U. S. ATOMIC ENERGY COMMISSION
REGION I
DIVISION OF COMPLIANCE

Report of Inspection

CO Report Nos. 289/70-3
320/70-3

Licensee: Metropolitan Edison Company
Three Mile Island Units Nos. 1 and 2
License Nos. CPPR-40 and CPPR-66

FIGURE I.
CO REPORT NO. 289/70-3
320/70-3

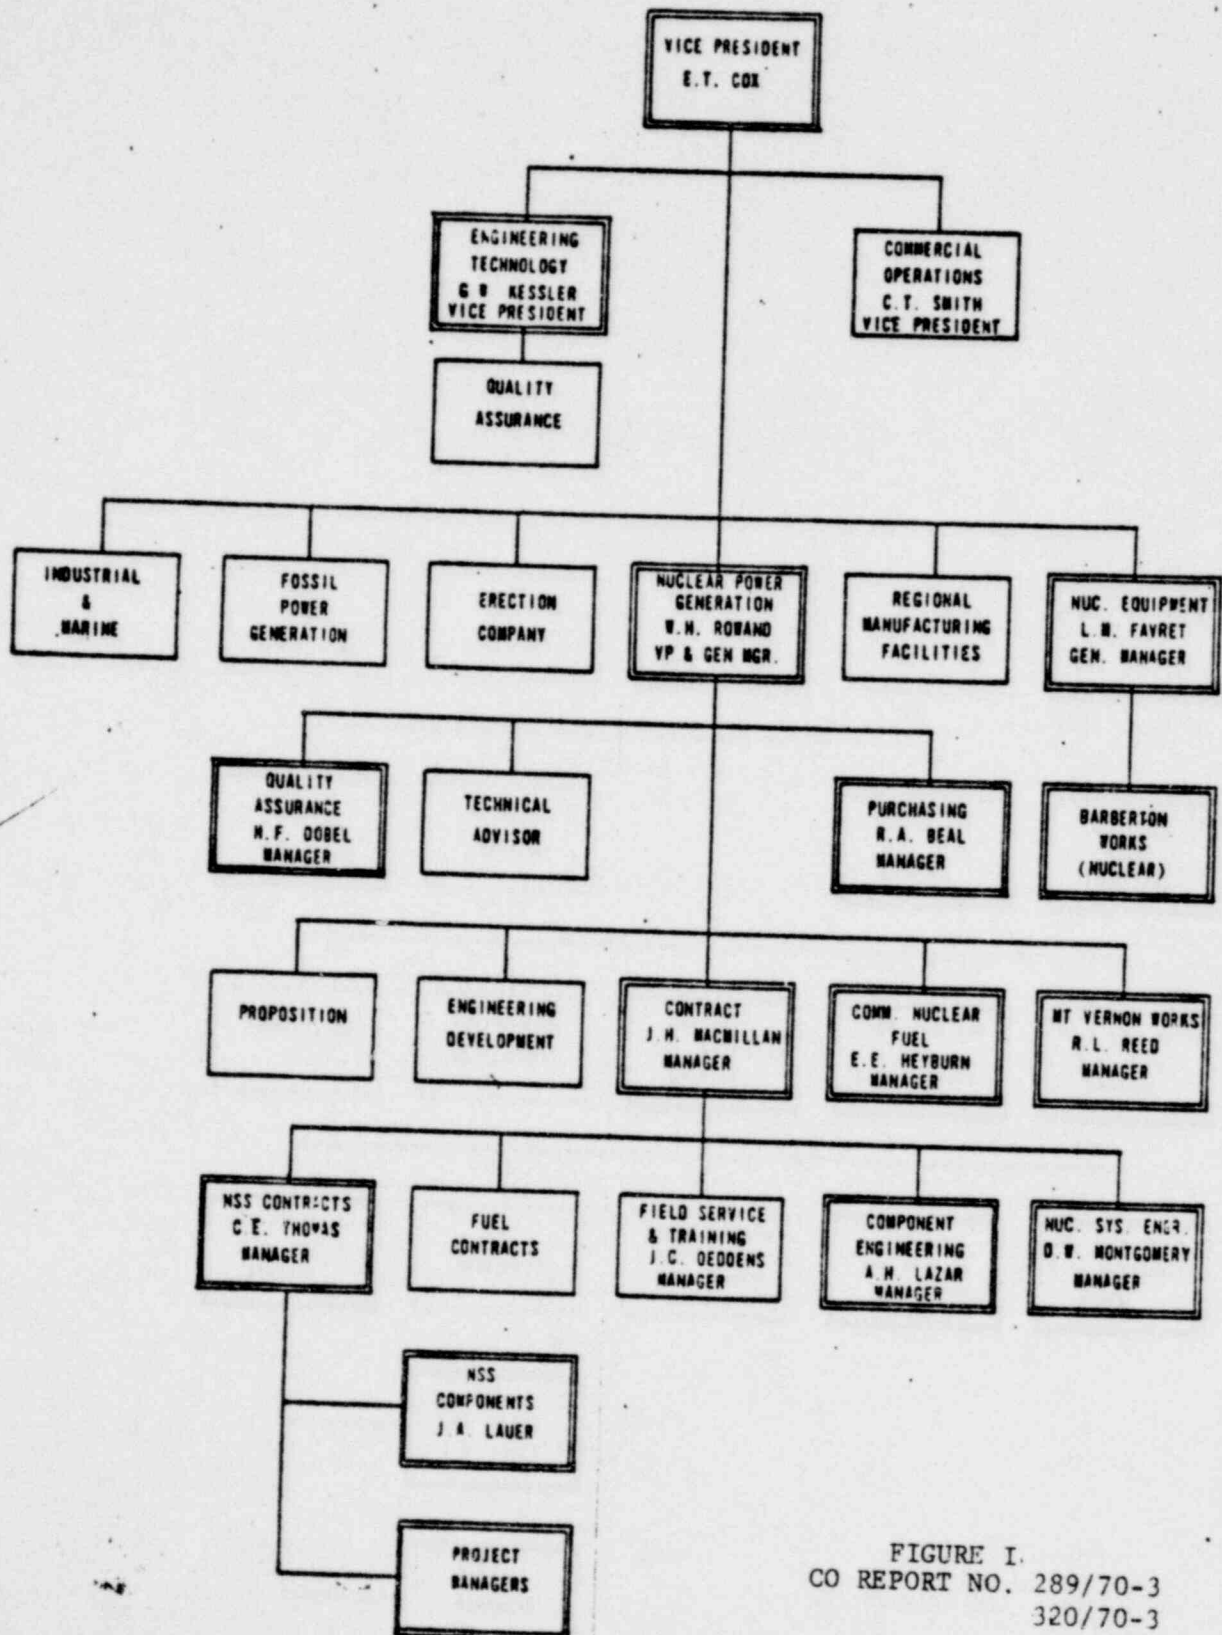
Babcock and Wilcox Company (B&W) Power Generation Division has been reorganized as shown on Figure I. The transition from the organizational structure previously reviewed to the present structure appears to have been well planned and smoothly accomplished.

The relationship between the Nuclear Power Generation Department (NPGD), QA organization (Lynchburg) and the Engineering Technology Department (ETD) QA organization (Barberton) was not clearly established during the inspection. The responsibilities of NPGD QA manager are clearly defined in the NPGD QA manual; however, a similar document was not reviewed for ETD QA. Both ETD and NPGD QA departments provide policy on QA/QC matters and potential conflicts are possible. The inspectors were informed that a task force appointed by the vice president of the Power Generation Division is studying this matter and will make recommendation regarding the need for additional organizational changes.

The B&W organization meets the commitments in the application and the intent of this criterion.
